ADDENDUM NO. 1

PROJECT: Water Heater Replacement at Clovercroft E.S. and Nolensville E.S.
WCS RFB #1415; EE#26-018

U.L. PP FLUE PIPE PENETRATION
NO SCALE

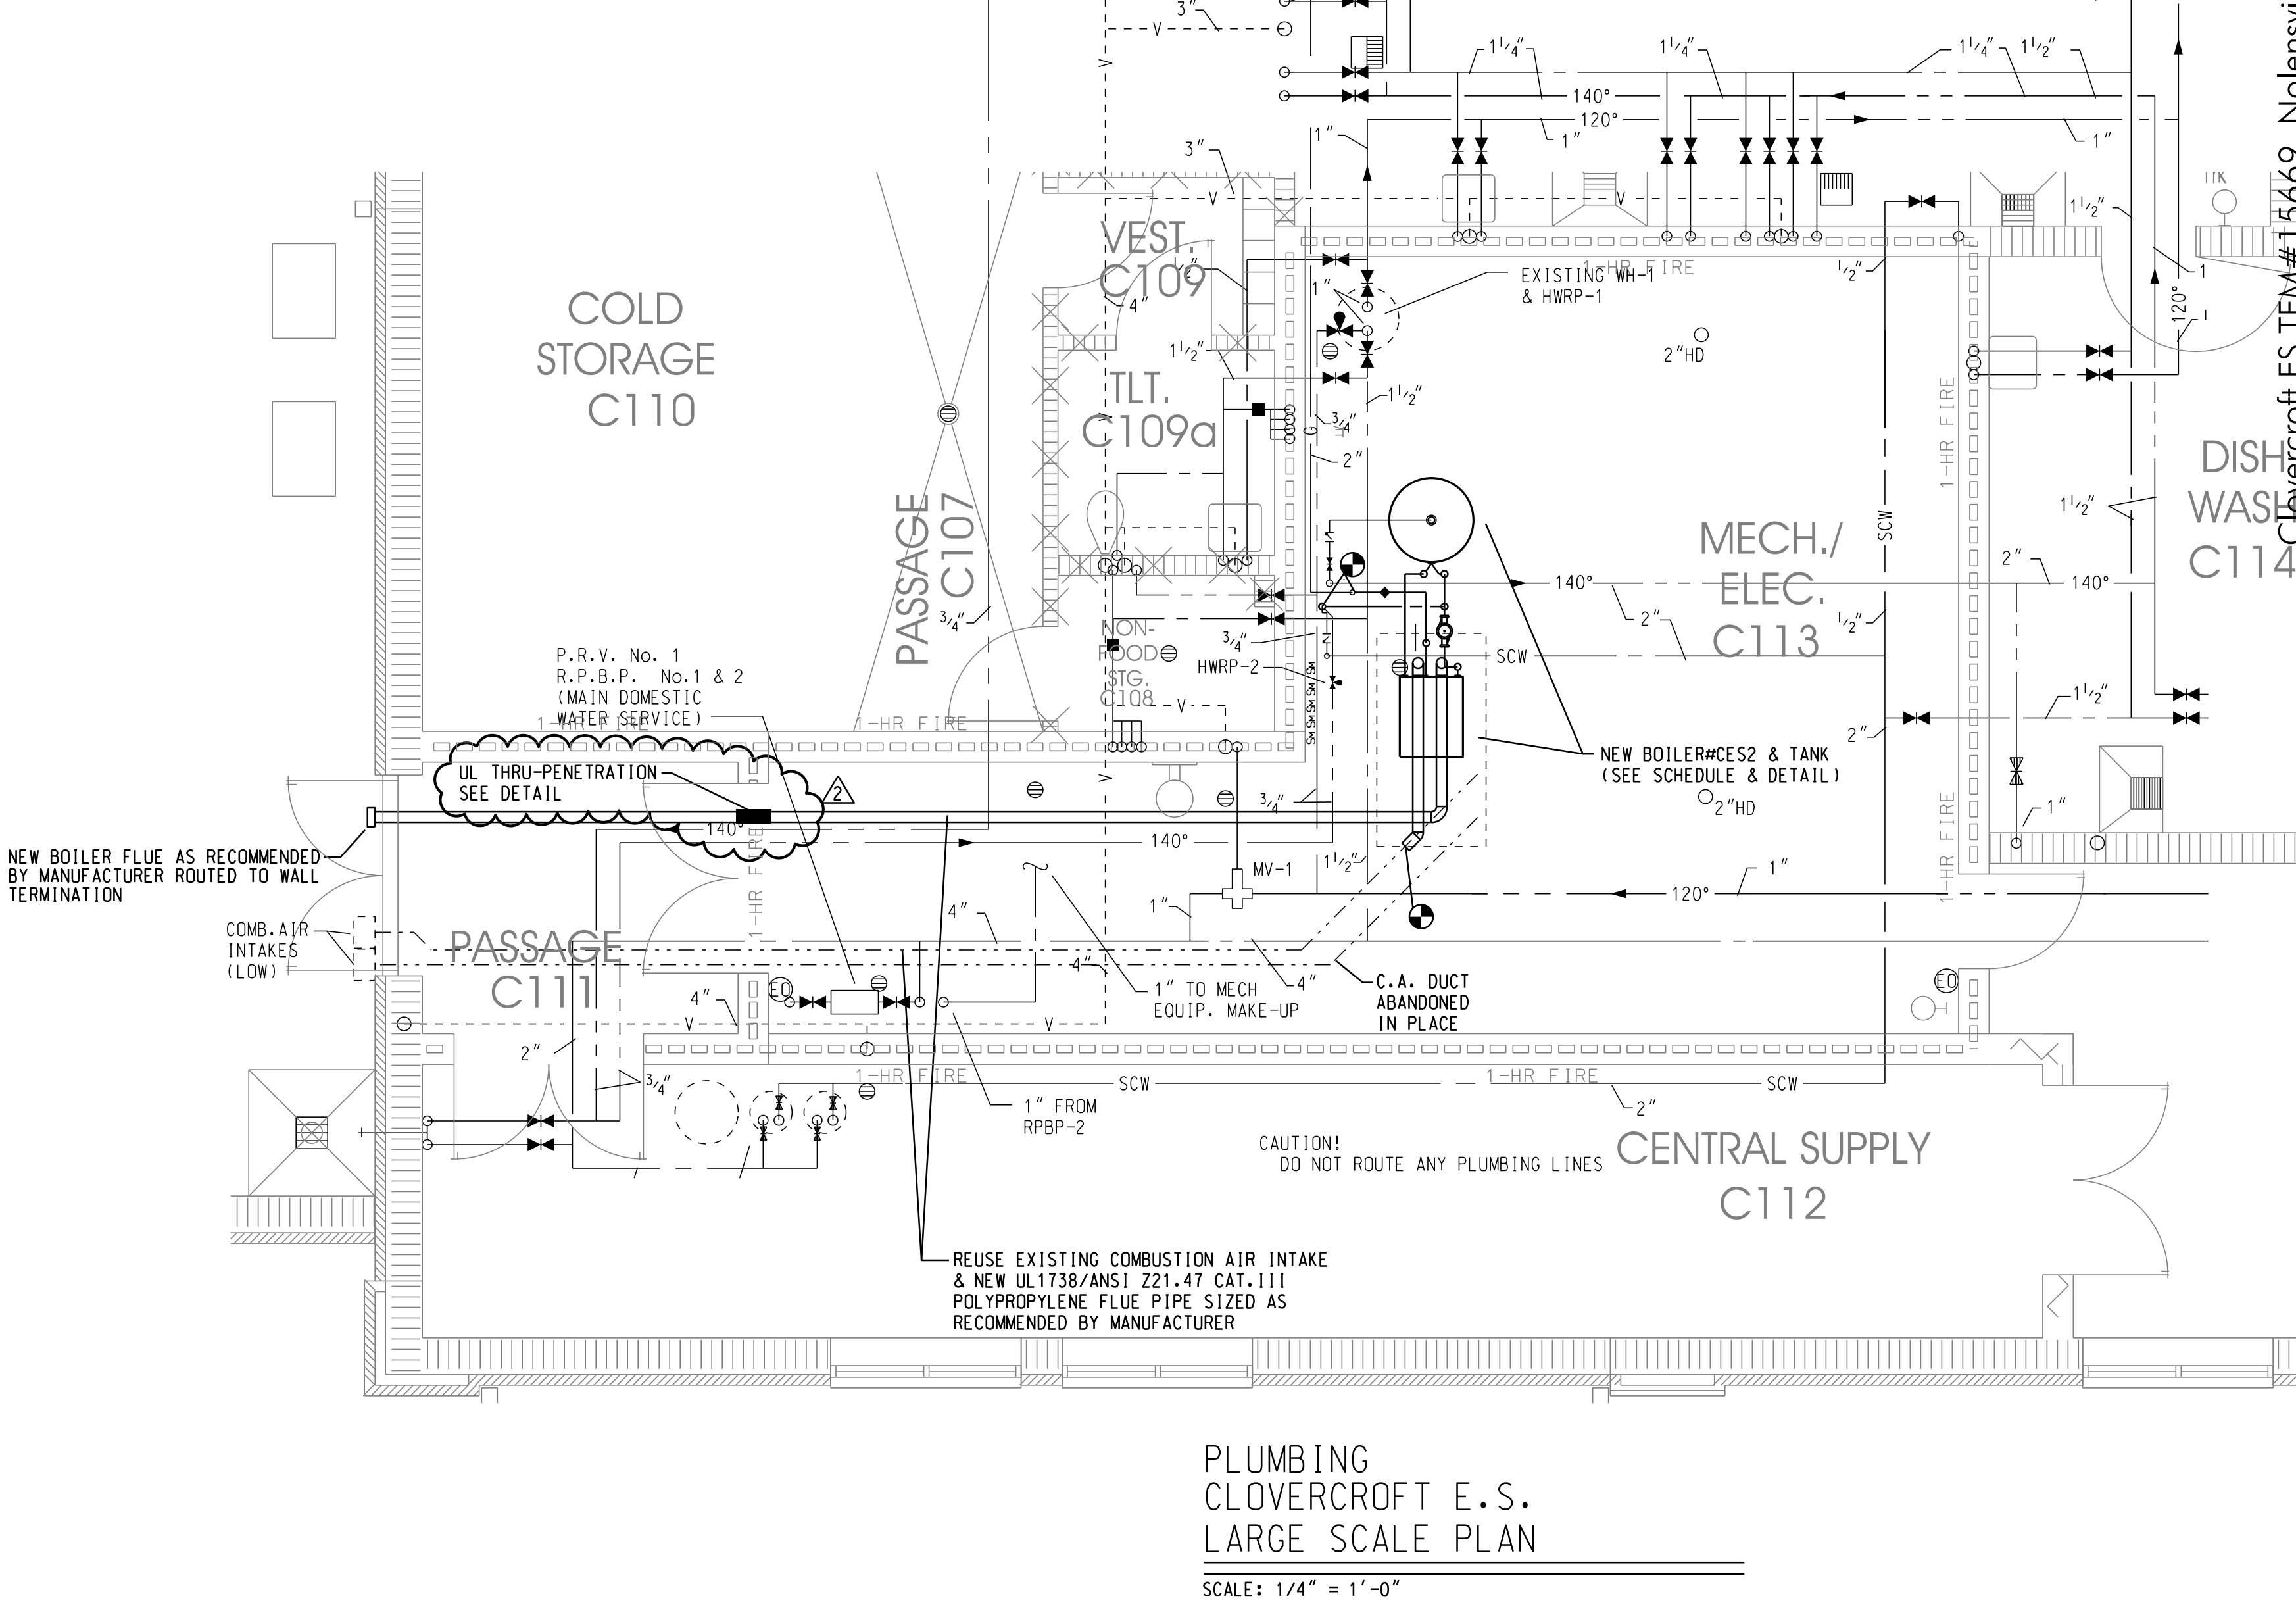
SHEET P2.1

1. ADD: UL Penetration Detail.
2. ADD: Notes to protect flue gas pipe penetration of rated wall – reference UL Penetration Detail.
3. See attached revised sheet P2.1 dated 7/21/2026.
